Report: TAB REPORT
Function: Test, Adjust, & Balance
Date: 07/19/2023

06-26-23 CARMAX #7179 - MILWAUKEE, WI

Issue List

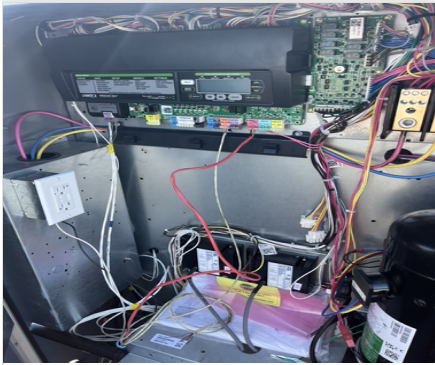
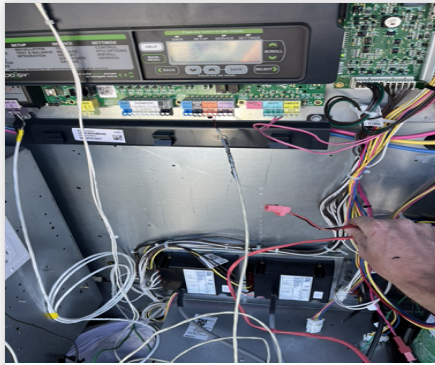
Issue Name : DI Smoke is not Landed in RTU-10
Description : DI Smoke input is not connected in RTU-10. Unsure of reason, left disconnected. Recommend service.
Created By : National TAB **Assigned To :** National TAB - Michael McDonnell
Status : Open
Originated Date : 08/31/2023 - Michael McDonnell - National TAB

PART PLAN – HVAC

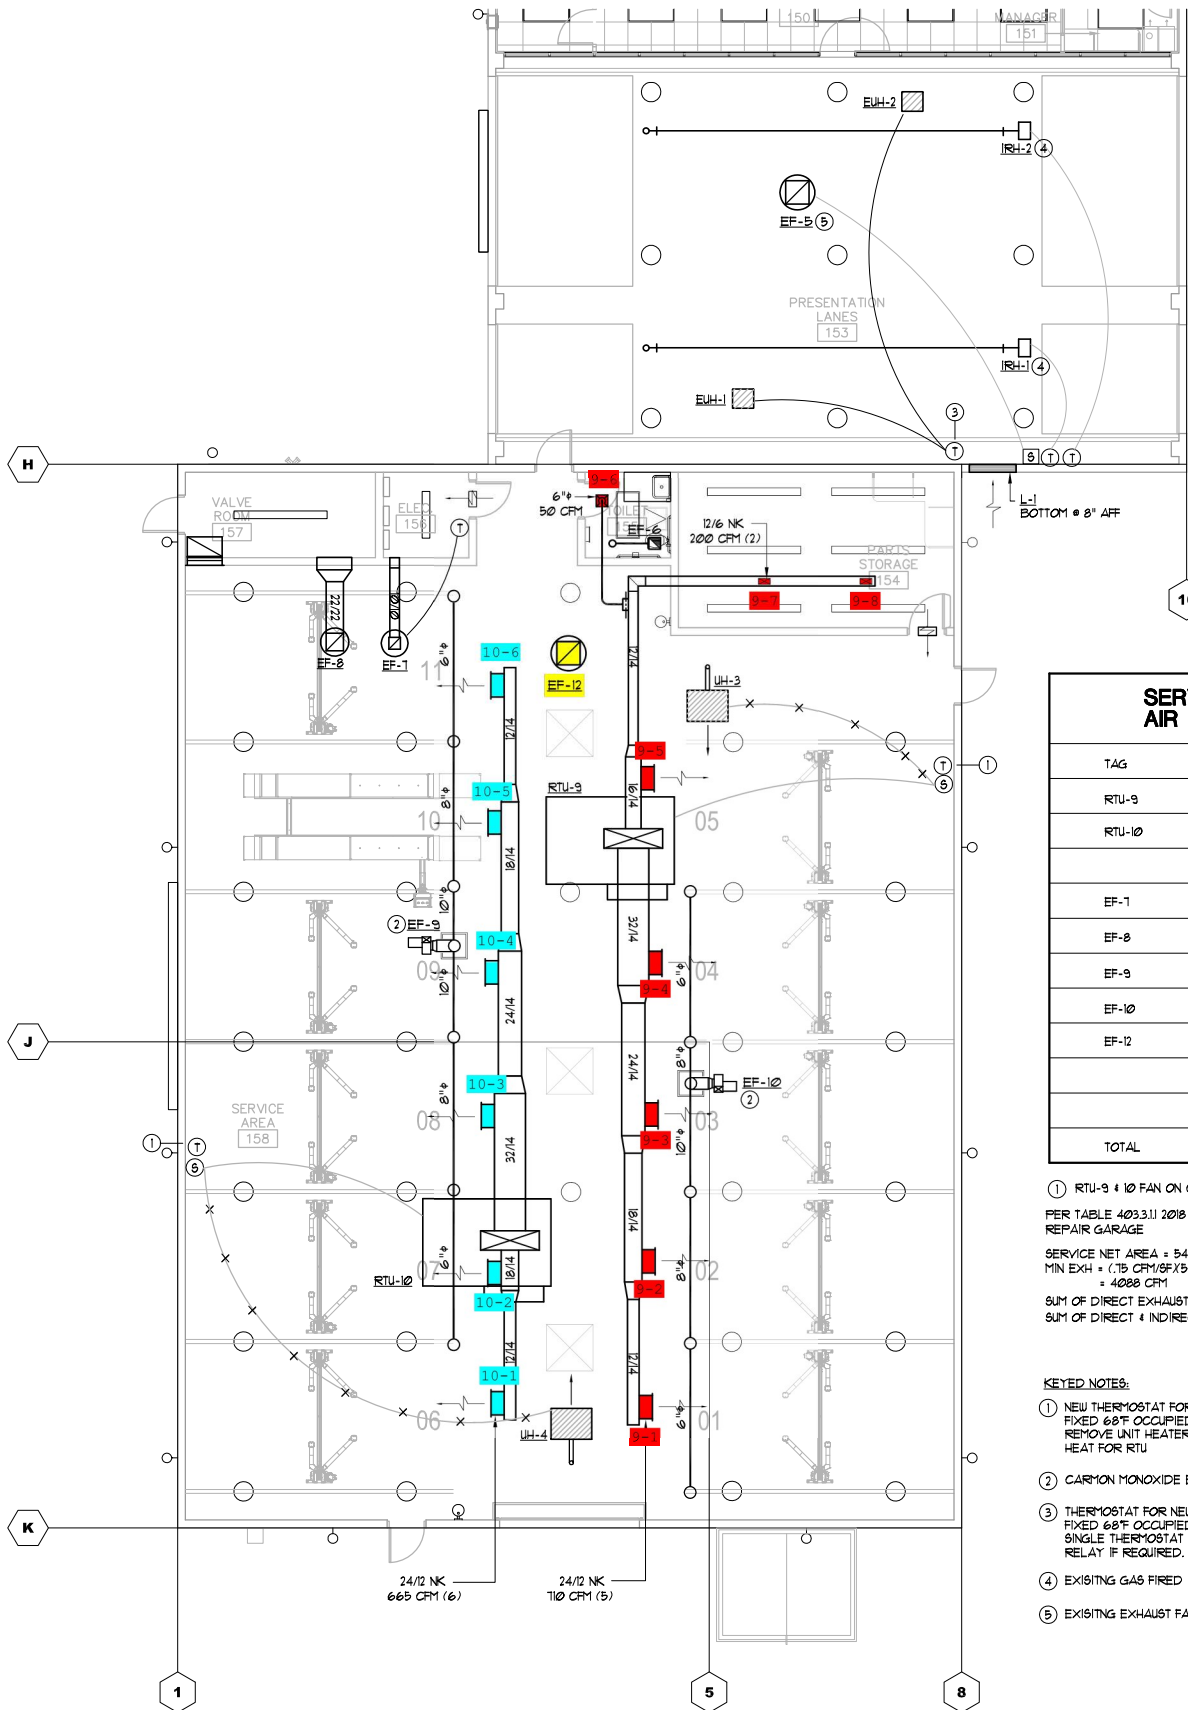
[1] UNABLE TO SLOW FAN TO DESIGN W/O SPEED CONTROL.
